SUBJECT: McGUIRE NUCLEAR STATION, UNITS 1 AND 2 - ISSUANCE OF AMENDMENTS RE: (TAC NOS. MA5994 AND MA5995)

The Nuclear Regulatory Commission has issued the enclosed Amendment No. 191 to Facility Operating License NPF-9 and Amendment No. 172 to Facility Operating License NPF-17 for the McGuire Nuclear Station, Units 1 and 2. The amendments consist of changes to the Technical Specifications in response to your application dated June 24, 1999, as supplemented by letter dated November 24, 1999.

The amendments revise the minimum reactor coolant system (RCS) flow rate limit, reduce the reactor coolant average temperature and pressurizer pressure limits, restrict operation to a RCS flow deficit of no more than one percent, and change the low RCS flow reactor trip setpoint.

ATTACHMENT TO LICENSE AMENDMENT NO. 191

Figure 2.1.1-1

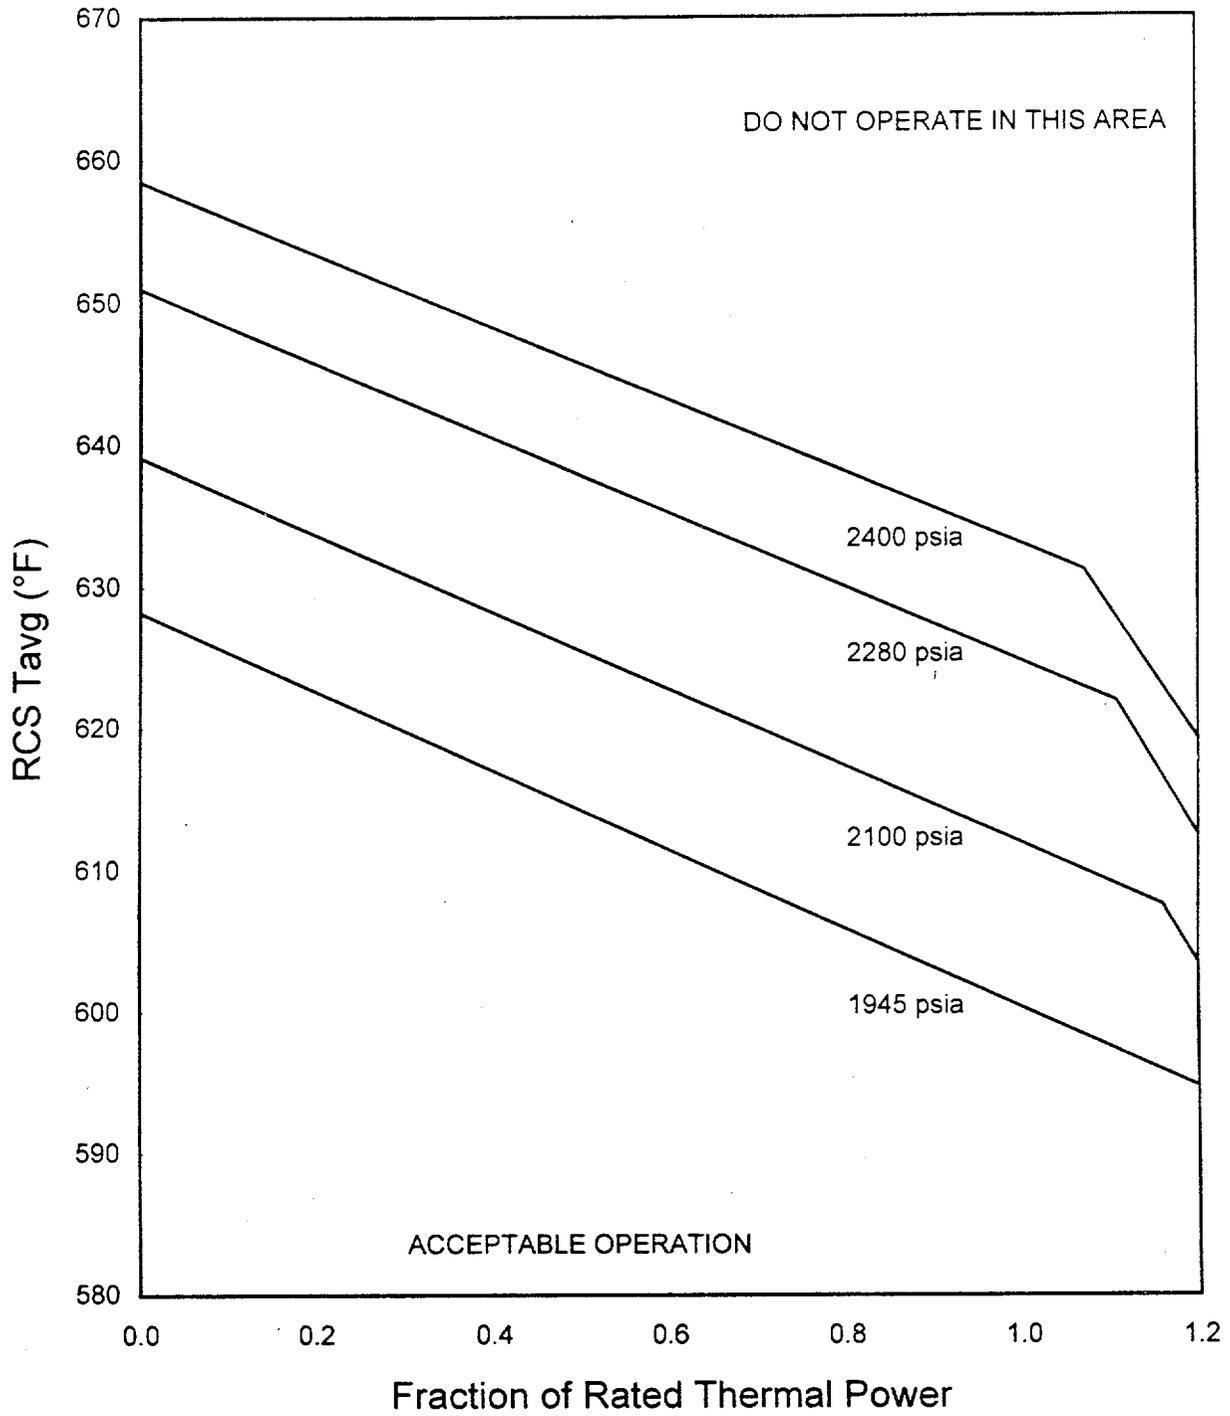
The Safety Limit curves in Figure 2.1.1-1 will be revised due to the proposed change in minimum RCS total flow rate limit to 390,000 gpm.

The safety limit curves in TS Figure 2.1.1-1, "Reactor Core Safety Limits - Four Loops in Operation," are revised. The safety limit curves show the loci of points of thermal power, reactor coolant system pressure and average temperature below which (1) the calculated DNBR is not less than the design DNBR limit or (2) the average enthalpy at the vessel exit is less than or equal to the enthalpy of the saturated liquid. These curves are revised slightly higher as a result of the increase in the RCS flow limit to 390,000 gpm. The safety limits do not affect the normal operation of the facility, but are only used to determine the need for further safety evaluations following postulated overheating or power excursion transients. Since the axial flux difference limits of LCO 3.2.3 are unchanged, all the current thermal hydraulic design criteria continue to be satisfied. The licensee has determined that the constants in the overtemperature ΔT (OT ΔT) and overpower ΔT (OP ΔT) setpoint equations are conservative and provide the necessary reactor protection. These OT ΔT and OP ΔT reactor trips are assumed in the Chapter 15 analyses.
